## ASSESSMENT REPORT

### WOOLOOWARE BAY TOWN CENTRE CONCEPT PLAN MP 10\_0229 MOD 5

**Figure 7:** Area of Family Hill within the required 40 metre riparian corridor

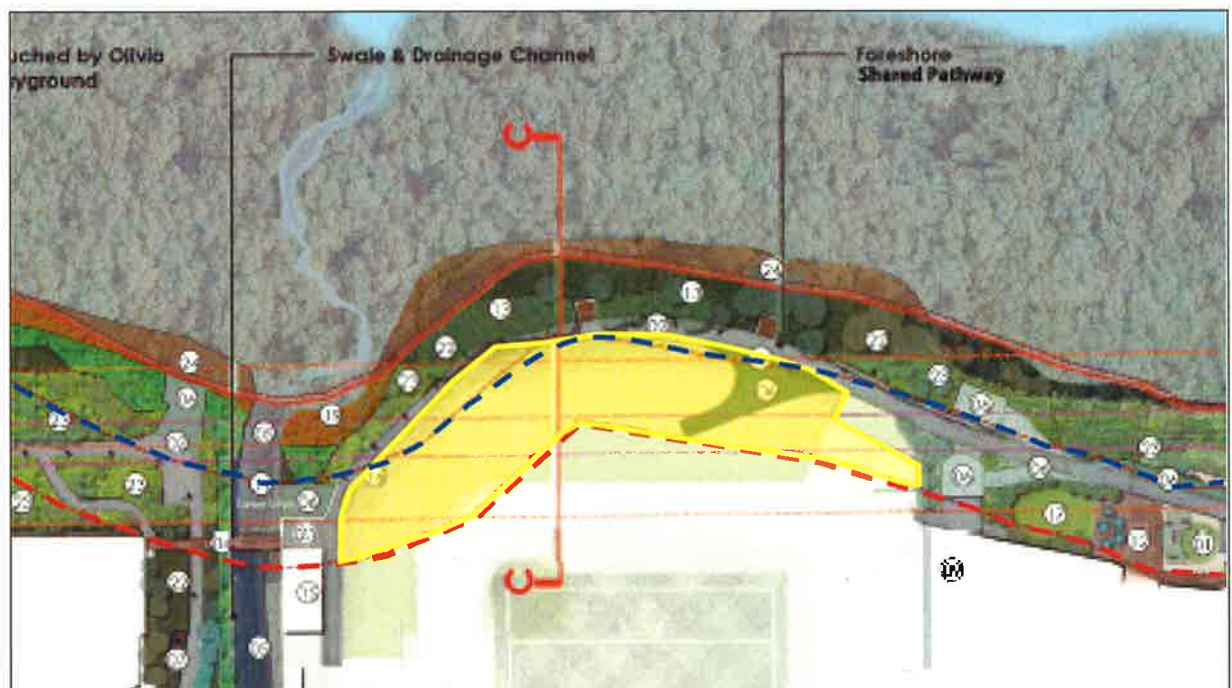
OEH objects to the proposal on the basis that it is inappropriate to exclude Family Hill from the riparian corridor without appropriate offsets elsewhere on the site. DPI also advises that if Family Hill is proposed to be retained for recreation, it should be offset elsewhere on the site.

The Department acknowledges that it was always envisaged to retain Family Hill in its current state. However, the Department notes the Concept Plan Approval applies to the entire site, including the existing stadium and Family Hill. Therefore, the Department considers it is appropriate to include Family Hill within the riparian corridor to ensure the potential impacts of the development across the entire site are fully assessed.

The Department considers the significant level of development across the wider site warrants an appropriate riparian buffer along the entire length of the waterfront. The Department, therefore, considers the NOW Guidelines should be applied to the entire waterfront setback area, and Family Hill be included within the VRZ for the purpose of calculating appropriate offsets.

Figure 8: Location of proposed offset planting

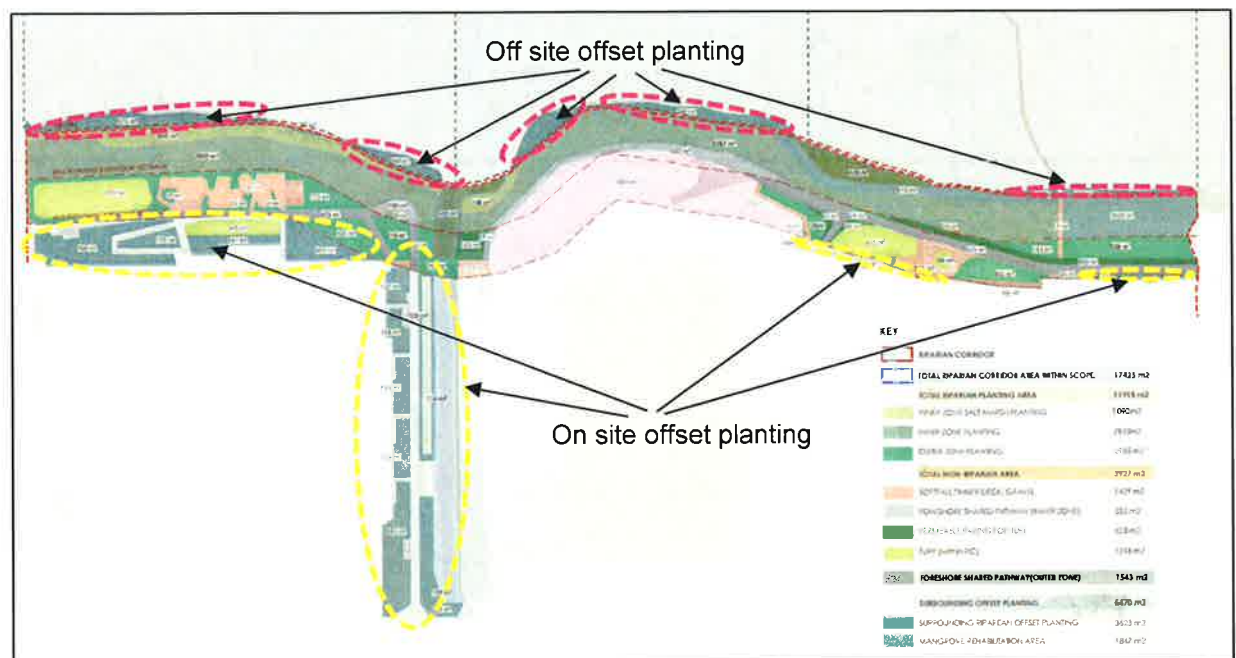
However, OEH and DPI raise concerns about the above proposed offset plantings:

- DPI advises that the Proponent has included vegetation adjacent to the drainage channel in the 3,722 m<sup>2</sup> offset, compared with the area surrounding the drainage channel which was approved with, and required a vegetated riparian corridor itself. The vegetated riparian corridor is in addition to the main corridor required along the northern boundary and cannot be included as offset for encroachments on the northern corridor.
- OEH and DPI advise that the proposed off-site should not be considered an offset as it is outside the development site, on land owned by RMS and, therefore, inconsistent with the NOW Guidelines, which require offsets to be provided on-site.

The Department agrees with DPI that the riparian corridor adjacent to the drainage channel is required in addition to the main riparian corridor and it is unreasonable to consider it as an offset for encroachments on the main riparian corridor. Riparian planting in this part of the site equates to 1,946 m<sup>2</sup>, so that, effectively only 1,776 m<sup>2</sup> of on-site planting is provided to offset encroachments on the main 40 metre corridor.
